Subject: 10CFR21 Reporting of Defects and Non-Compliance -
Engine Systems, Inc. Report No. 10CFR21-0121, Rev. 0

Refurbished Pressure Regulator Assembly, P/N 1776 506

10CFR21 REPORTING OF DEFECTS AND NON-COMPLIANCE

COMPONENT: Pressure Regulator Assembly - Component Omitted During Refurbishment
P/N 1776 506

Figure 1: Outline Dwg of Pilot Valve Portion of Regulator Assembly

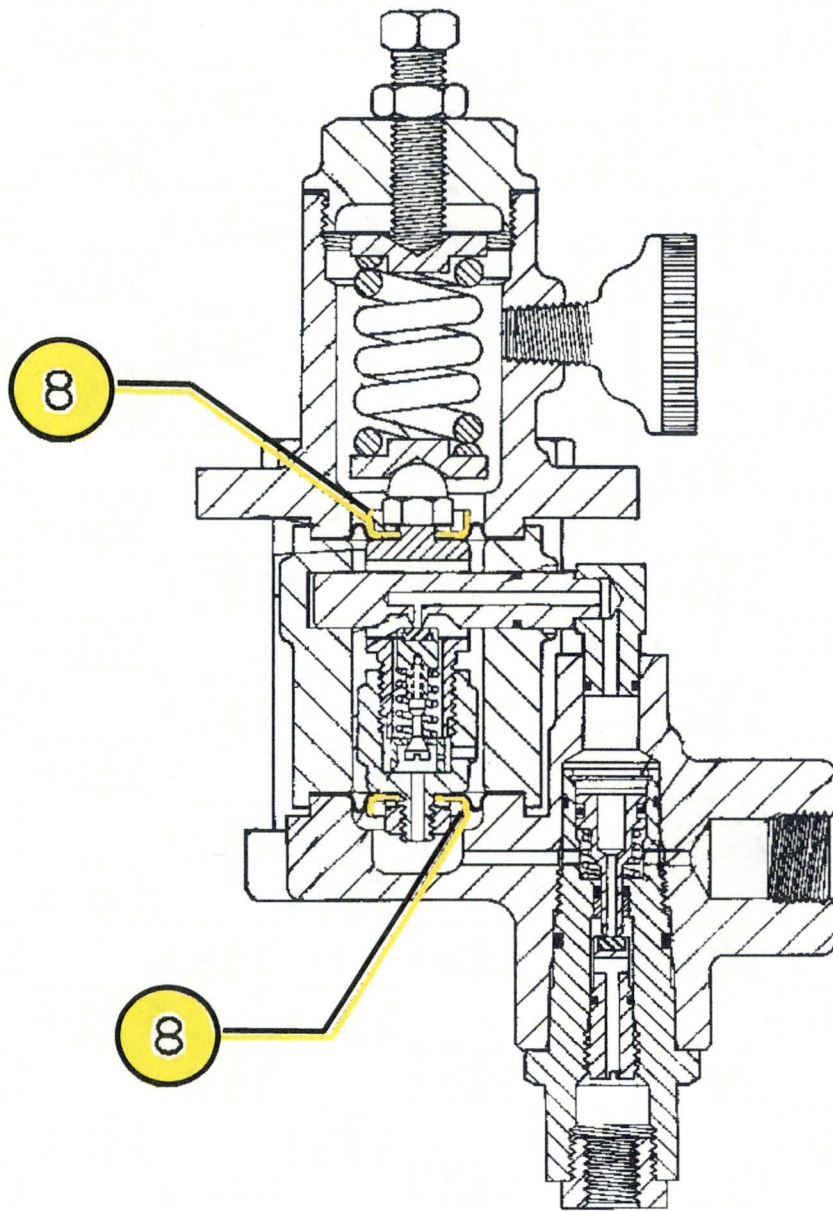
ESI supplied a refurbished pressure regulator assembly, P/N 1776 506, S/N 20776487, to Brunswick Nuclear Plant in August 2017. ESI later determined that two components of the assembly, an upper and lower diaphragm plate, were omitted during reassembly of the refurbished regulator. Reference item 8 on Figure 1 for location of the diaphragm plates within the pilot valve portion of the regulator assembly. These metal diaphragm plates distribute load and retain the associated rubber diaphragm. Omission of the metal plate may not initially affect operation of the pilot valve and therefore may not be detected during functional testing; however over repeated cycles there is a strong possibility that the rubber diaphragm would tear or rupture without the benefit of load distribution and support provided by the metal diaphragm plate.

Item 8 is the diaphragm plate

The assembly has been recalled and will be reworked by ESI using a new, dedicated repair kit and re-assembled and tested per approved procedures. An additional QA inspection will be performed to ensure presence of the diaphragm plates. This activity will be completed within the next 30 days.
